DEVELOPMENT APPLICATION: FIGHTING PIKE DATA CENTER
PLANNER: City of Williston/SRF Consulting Group

INTRODUCTION

This staff report provides a review and recommendations regarding the development proposal for the Fighting Pike data center complex. The staff report is organized as follows:

Figure 6. Landscaping Plan

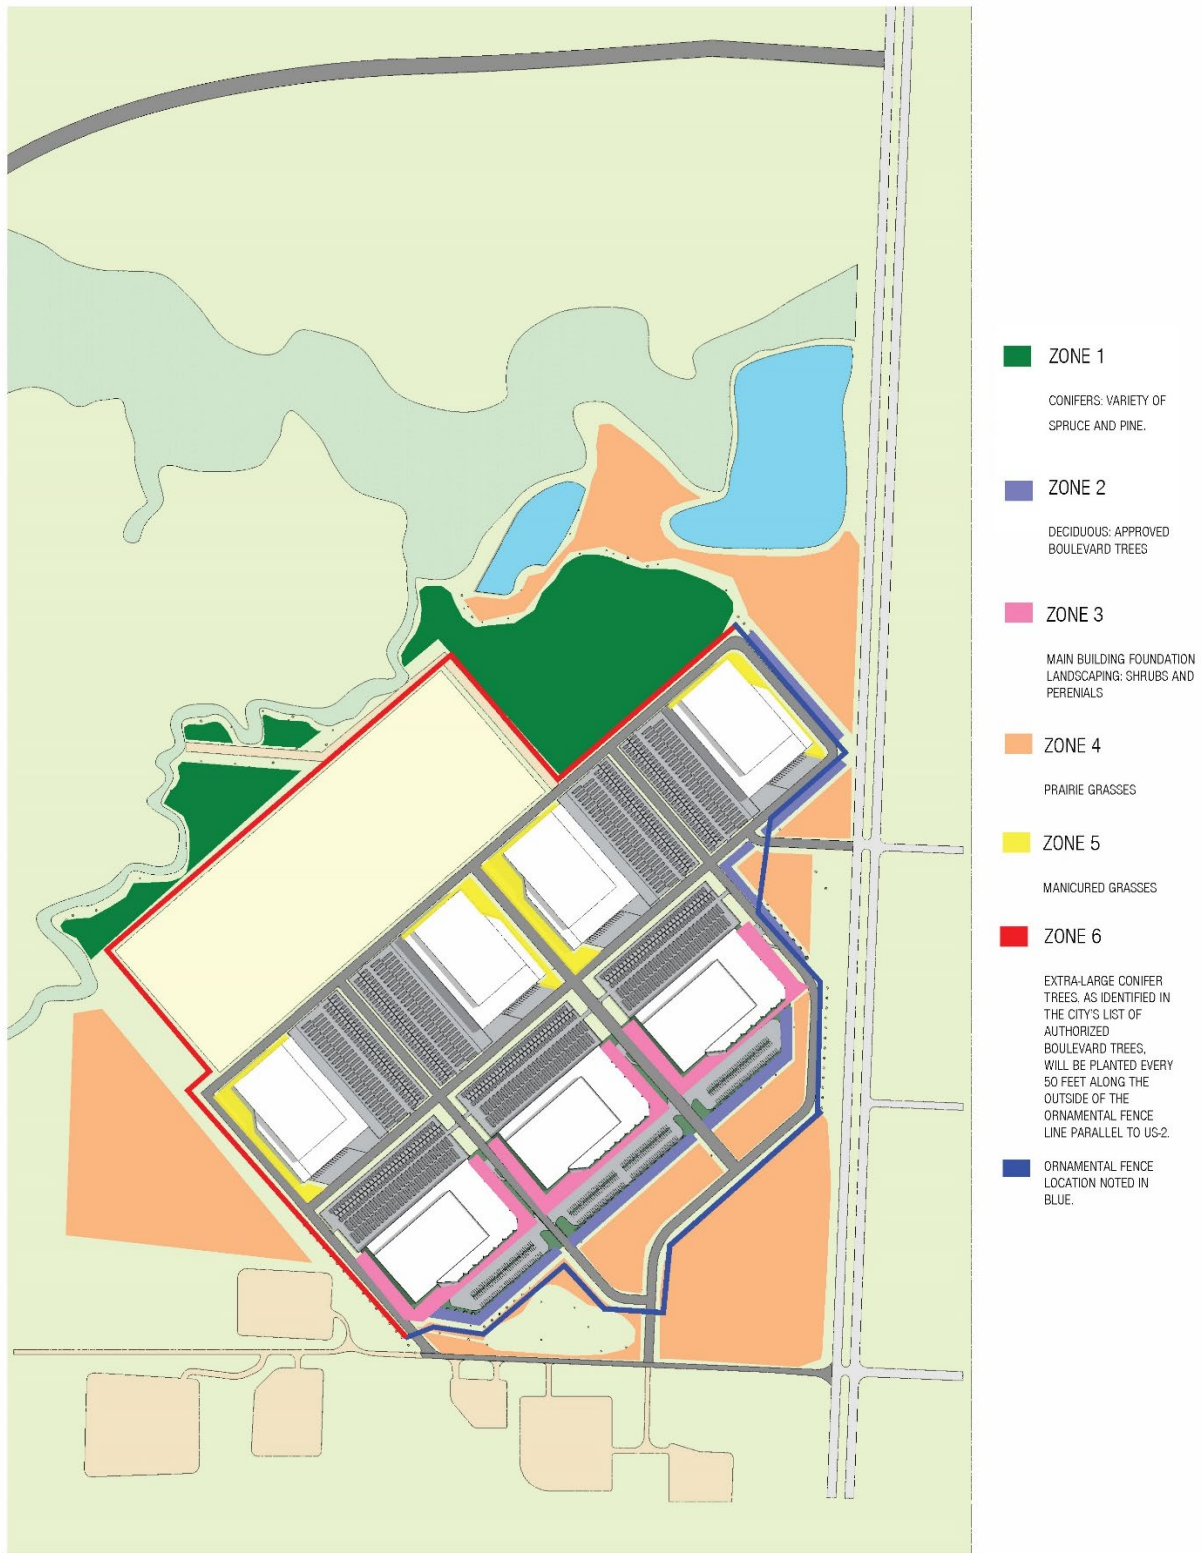
Figure 6, below, shows the applicant's landscaping plan. The landscaping plan identifies six zones, which utilize various plant types and levels of landscaping. Recommended standards for the Planned Unit Development are detailed in the following pages.

- **Phasing.** All of Zone 1, Zone 4 facing US 2 frontage, and Zone 6 facing US 2 frontage will be installed as part of the first building phase. As building phases continue, landscaping shall be installed adjacent to each building, as shown on the site plan.

- “US 2 frontage” is intended to extend from the northerly point of building 2.3 on the preliminary site plan to the southernmost point on building 3.2.

- **Zone 1.** Extra-large conifer trees, as identified in the City’s list of [Authorized Boulevard Trees](#), will be planted at a rate of nine per acre to help screen the west side of the power utility area from future residential uses to the west of the development parcel, as identified on the Future Land Use Map from the Comprehensive Plan.

- **Zone 4.** Native prairie grasses will be planted to incorporate the natural ground cover surrounding the site. Any reclaimed portions of the existing gravel pit in the southwest corner of the property will need to be seeded and restored with native prairie grasses. Establishing a native prairie planting of grasses and wildflowers requires management of the vegetation for at least for the first three years after seeding to ensure that the new native seedlings have a chance to grow and mature. Once the plants are mature, after two or three growing seasons, they will be better able to withstand impacts from weeds and other disturbances. The following management plan shall be followed for the zone. **The property owner or a designee shall provide a report to the city on an annual basis to report on progress in following the plan and compliance with the plan.**

- For Zone 4, the applicant shall develop a wildfire management plan in coordination with the City Fire Department.
- **Zone 5.** Irrigated turf will be planted and maintained.
- **Zone 6.** Extra-large conifer trees, as identified in the City's list of Authorized Boulevard Trees, will be planted every 50 feet along the outside of the ornamental fence line parallel to US 2.
- **All Zones.** All landscaping will follow the following requirements established in Section 25.R of the Zoning Ordinance:
 - Part 1.b(iii). Plant Quality
 - Part 1.b(iv). Plant Lists
 - Part 1.b(v). Installation
 - Part 1.b(vi). Maintenance
 - Part 1.b(viii). Soils
 - Part 1.b(ix). Visibility
 - Part 1.b(x). Overhead Utility Line Interference
